Southern Nuclear Operating Company
Vogtle Electric Generating Plant Units 3 and 4
Revision 2 to Request for License Amendment:
Use of AWS D1.1-2000 Criteria for Structural Welds (LAR-15-009R2)

Revised Request for License Amendment Regarding
Use of AWS D1.1-2000 Criteria for Structural Welds
(LAR-15-009R2)

Revised Proposed Changes to Licensing Basis Documents
(LAR-15-009R2)

Figure 1. Fillet Weld Loading In-Plane of Weld

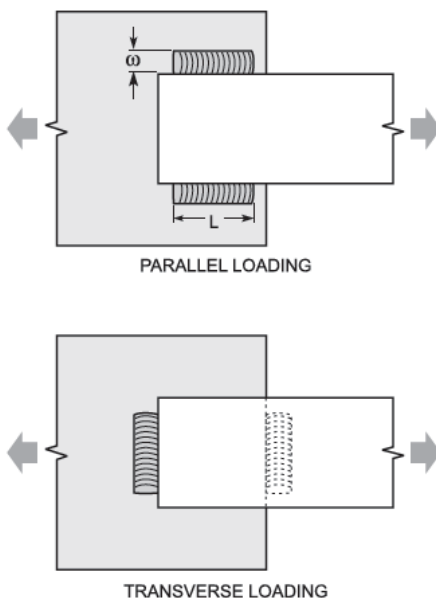
These changes are supported by industry tests that provide the justification for criteria that consider the load directionality. The testing and analysis is reported in an AISC Journal Article, “*Proposed Working Stresses for Fillet Welds in Building Construction*,” by T. R. Higgins and F.R. Preece. The referenced Higgins and Preece paper describes tests on linear fillet welds loaded both parallel to and transverse to the axis of the weld in the plane of the weld, as illustrated in Figure 1. The Higgins and Preece paper provides a factor of safety summary related to a working stress of $0.30F_{EXX}$. The summary of test results demonstrates that the failure of the weld loaded transverse to the axis of the weld is approximately four times $0.30F_{EXX}$.

For linear fillet weld groups concentrically loaded in the plane of the weld and consisting of elements oriented both longitudinally and transversely to the direction of applied load, additional provisions are proposed to be included in UFSAR Subsections 3.8.3.2 and 3.8.4.2 to supplement the provisions for directionality included in AWS D1.1-2000. These supplemental provisions address the deformation capability of the elements when combined in a weld group.

Figure 1A. Supplemental Provisions for Weld Groups with Longitudinally and Transversely Loaded Elements

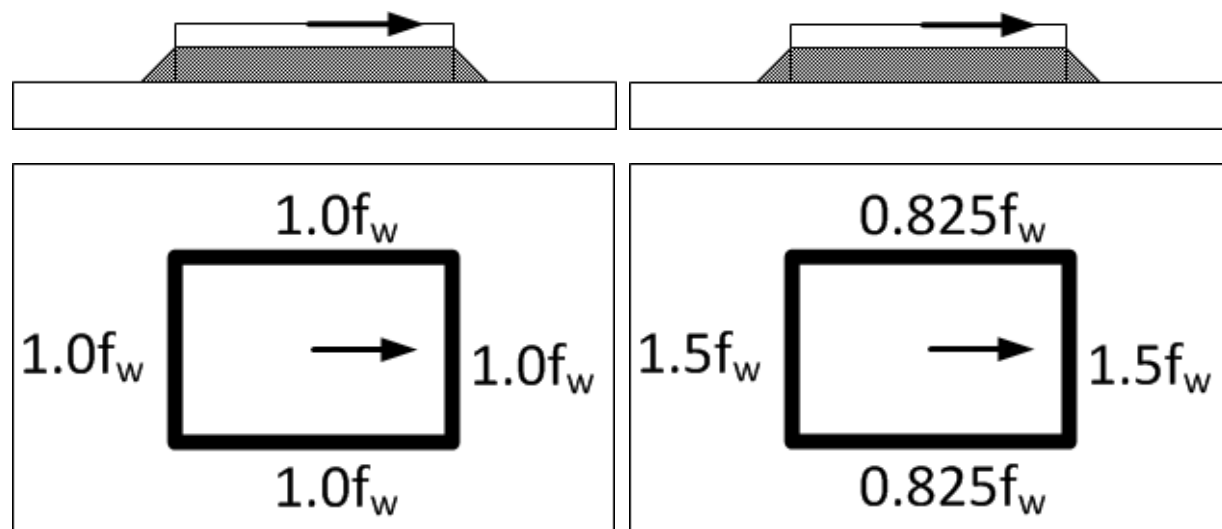
The strength of the weld group is limited to the larger of (1) the combined strength of the individual weld elements using 1.0 times the strength of the longitudinally oriented element and 1.0 times the strength of the transversely oriented element and (2) the combined strength of the individual weld elements using 0.825 times the strength of the longitudinally oriented element and 1.5 times the strength of the transversely oriented element as illustrated in Figure 1A. These supplemental provisions are more conservative than those in AWS D1.1-2000 and are consistent with provisions in AWS D1.1-2010 Section 2.6.4.4 and Table 2.4 and AISC 360-2010 Section J2.4 (c).

For fillet weld groups concentrically loaded in the plane of the axis of the weld and consisting of elements oriented both longitudinally and transversely to the direction of applied load, the deformation capability of the elements shall be considered. As a supplement to the provisions in AWS D1.1-2000, the strength of the weld group is limited to the larger of the two following evaluations:

Figure 3. Circular Fillet Weld Group

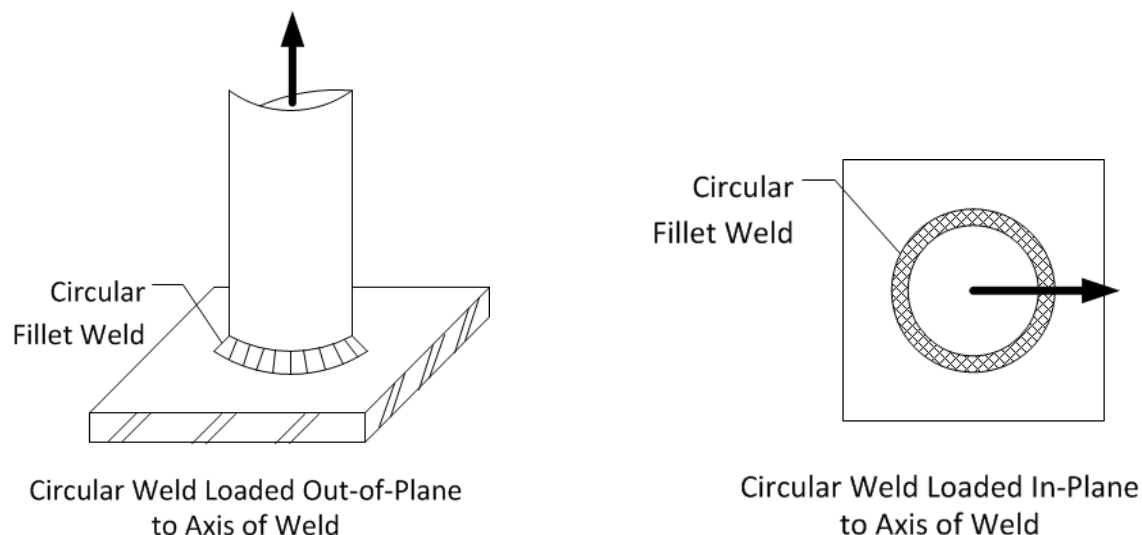
Circular fillet weld groups (e.g., fillet welds to anchor reinforcing bars, fillet welds to round rods, fillet welds to round tubes) are illustrated in Figure 3. A circular-shaped weld group concentrically loaded out-of-plane to the axis of the weld has a loading condition and behavior equivalent to a weld group consisting of straight lines because the shift in the fillet failure angle resulting in the increase in the strength of the weld occurs in the same way whether the axis of the weld is straight or circular. The parameter of interest is the angle that the applied force makes with the axis of the weld.

The use of directionality for circular welds is limited to tension loading concentrically applied out-of-plane to the axis of the weld. For circular welds loaded in-plane to the axis of the weld, the angle of loading measured from the weld longitudinal axis is constantly varying. Due to this complexity, application of AWS D1.1-2000 Section 2.14.4 is excluded for circular welds loaded in-plane to the axis of the weld. The limitation on the use of directionality to out-of-plane load for circular weld groups is included in the licensing basis changes in UFSAR Subsections 3.8.3.2 and 3.8.4.2.

- Where directionality is considered for concentric out-of-plane loading for linear fillet weld groups, including lines and rectangular configurations, the directionality provisions in AWS D1.1-2000 are applied.
- Where directionality is considered for concentric out-of-plane loading for circular-shaped fillet weld configurations, the directionality provisions in AWS D1.1-2000 are applied. The use of directionality provisions in AWS D1.1-2000 for circular-shaped fillet weld configurations is limited to tension loading concentrically applied out-of-plane to the axis of the weld.]*
